UNITED STATES PATENT AND TRADEMARK OFFICE

10/766,324

Office Action Summary

DETAILED ACTION

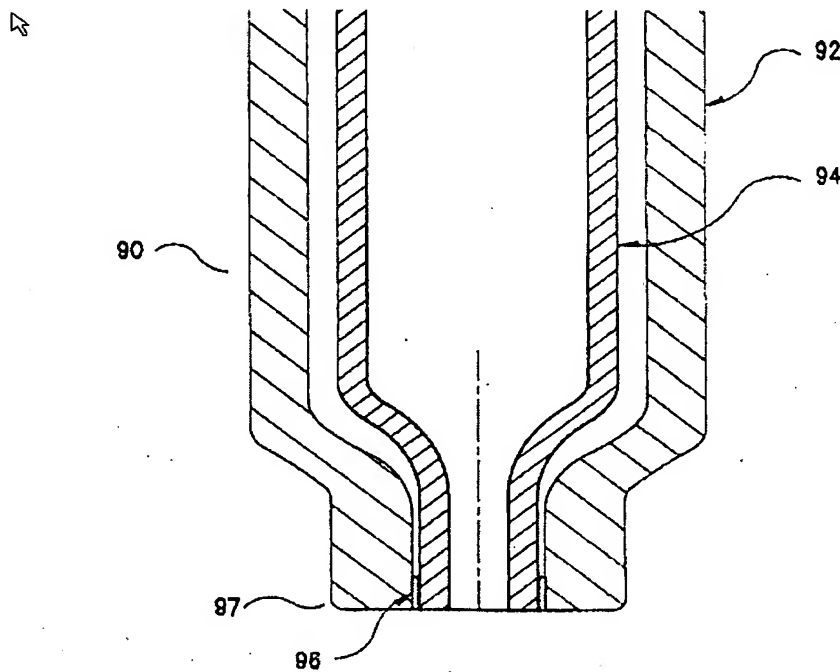
4. Claim 1 is rejected under 35 U.S.C. 102(b) as being anticipated by Holt (US 5468453).

Holt teaches a pipette probe in an automated chemical analysis system. The probe comprises an inner tube (94) made up of PTFE and therefore is at least partially gas permeable. The probe further comprises an outer tube (92) that surrounds the inner tube (94). (See Figure below) (See abstract)
